Our Reference: 24-0386-002-L-SS

Submission – Proposed Planning Scheme Amendment C244melt

- 527-555 Mount Cottrell Road, Grangefields.

15 Bodycoats Road, Wollert – Subdivision Layout Plan

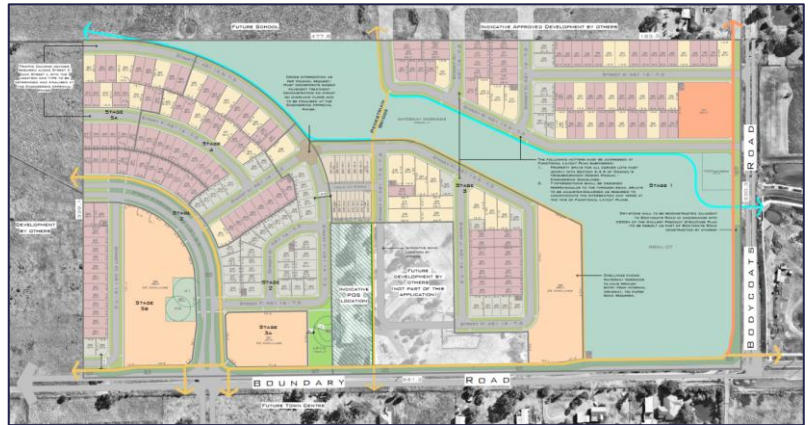
As an example of the limitations of industry standard product to achieve density, the below is excerpt is the Subdivision Layout Plan for 15 Bodycoats Road, Wollert. As per the requirements of the Wollert PSP, this site must achieve 30 dwl/ha. Long lengths of single sided road, wide roads, curved roads, tree reserves, irregularity of the land has made 30 dwellings unachievable without the use of strata development outcomes and mandating the Superlots to achieve the density shortfalls.

Therefore to achieve 30 dwl/ha, this project comprises:

- 34% strata lots;
- 79% of green title lots being SLHC; and
- 40% of green title lots being 8.5m front loaded.

527-555 Mount Cottrell Road – Scenario 1 Indicative Design

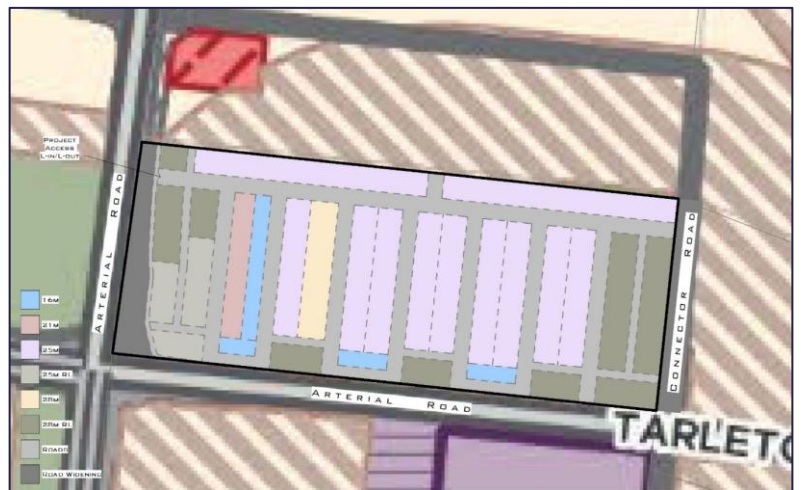
The lot mix selected is based on current market conditions with a higher emphasis on rear loaded lots to assist to achieve the highest possible densities. Based on the above, the following densities can be achieved.

As demonstrated above, there is a material reduction in density output due to the removal of front loaded residential allotments less than 10.5m in width.

527-555 Mount Cottrell Road – Scenario 2 Indicative Design

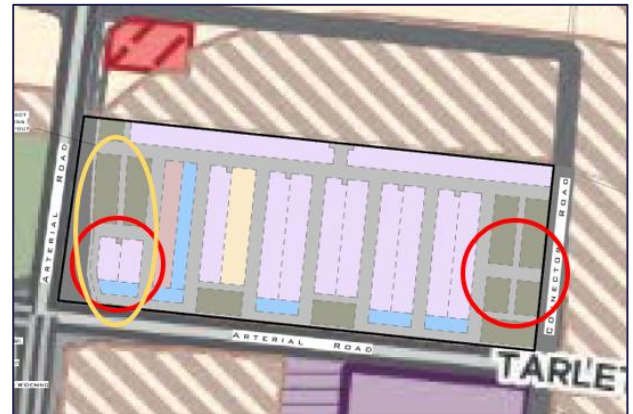
This scenario starts to embed some of the additional detailed considerations of the draft Melton East PSP, such as laneway lengths being between 50-80m and their design parameters. As circled in red, the limitation on laneway lengths necessitates the introduction of additional roads, increasing road consumption by approximately 1.7% and a reduction in density by approximately 3% across the landholding. If this is isolated to the yellow circle, it results in 69% more road than otherwise would have been necessary. When this is extrapolated across the PSP as rear loaded housing is intended to abut arterial/connector roads and open space, this will be a significant impact on density, affordability and the heat island effect by unnecessarily adding hard surfaces.

Similarly to Scenario 1, the exclusion of lots less than 10.5m reduces the overall yield in this scenario by 7%.

PSP Performance Summary

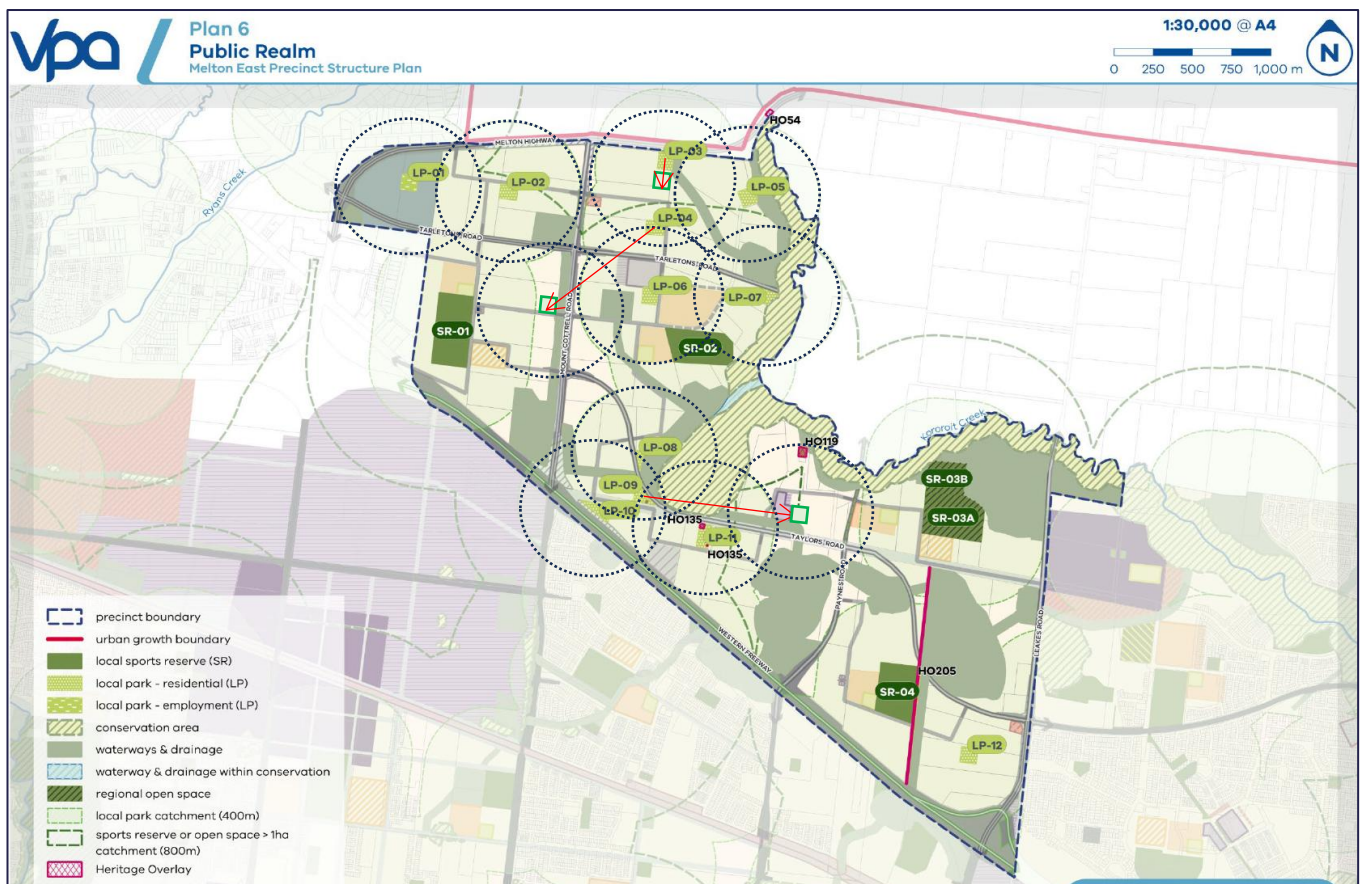
We note the distribution of Local Parks in the northern part of the draft Melton East Precinct Structure Plan and the overlapping of catchments as a result of Public Open Space being located in close proximity to each other. This has created two distinct pockets within the Place Based Plan that fall outside of the 400m walkable catchment of a Local Park.

We further note the location of some Local Parks have created catchments that fall outside the Urban Growth Boundary and could be refined to increase the benefit to the Melton East precinct and be re-located away from Arterial Roads to improve the amenity of the open spaces.

In our view, there is a clear opportunity to re-distribute the Local Park network in the northern part of the draft Melton East Precinct Structure Plan to increase the dwellings within the 400m walkable catchment and increase the percentage within this catchment from 82% to 90-95%.

- Shifting LP-03 further south to ensure a greater amount of the 400m walkable catchment is within the Melton East PSP.
- Re-locating LP-04 south-west to adjoin Mount Cottrell Road and reduce the overlap of catchments and capture a gap within the distribution of Public Open Space.
- Re-locating LP-09 to reduce the overlap of catchments and capture a gap within the distribution of Public Open Space.
